Access Compliance Report

Public Rights-of-Way

(Curb Ramps)

Intersection ID: 12632	Main Street: SEIGLE_AV	Cross Street: SKYLINE_VIEW_WY	Location: N
ADA ID: BE0C1DF701EC	Ramp Type: Directional1	Initial Pass/Fail: Pass	Overall Compliance: No
		Severity Score: 7.75

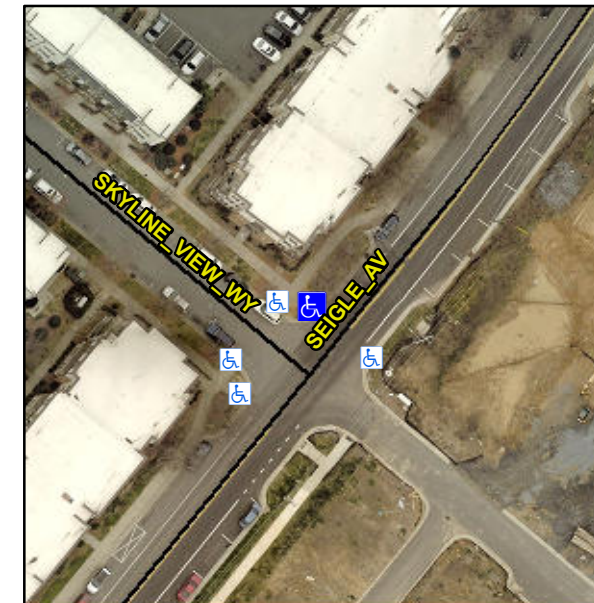
**R304.5.3, R304.2.2-Perp, R304.3.2-
Para, R302.7.2**

Compliance	Description	Data	Compliance	Description	Data
N/A	Ramp Length (in)	146.0	Yes	Grade Break?	Yes
Yes	Ramp Width (in)	70.0	No	Grade Break Slope (%)	5.4
Yes	Ramp Slope (%)	6.1	Yes	Grade Break XSlope (%)	1.6
No	Ramp XSlope (%)	3.8			
Yes	Flare Type LT	N/A	Yes	Flare Type RT	N/A
N/A	Flare Slope LT (%)	N/A	N/A	Flare Slope RT (%)	N/A
N/A	Flare Traversable LT?	No	N/A	Flare Traversable RT?	No
Yes	Landing Length (in)	72.0	Yes	DWS Provided?	Yes
Yes	Landing Width (in)	71.0	Yes	DWS Contrast?	Yes
No	Landing Slope (%)	2.3	Yes	DWS Length (in)	25.0
No	Landing X Slope (%)	3.0	Yes	DWS Full Width?	Yes
N/A	Landing Curb? (Y/N)	N/A	Yes	DWS Offset LT (in)	2.0
N/A	Shared Landing?	Yes	Yes	DWS Offset RT (in)	20.0
Yes	Gutter Ponding?	No	Yes	Gutter Slope (%)	2.4
No	Gutter Lip Ht (in)	0.5	Yes	Gutter X Slope (%)	3.1
N/A	Painted X Walk1?	No		Road Slope (%)	4.3
	X Walk 1 Direction	To SE		Road X Slope (%)	3.6
	X Walk 1 Width (in)	N/A		Clear Space?	Yes

**Remove & Replace Entire Ramp.
Grind Gutter Lip.**
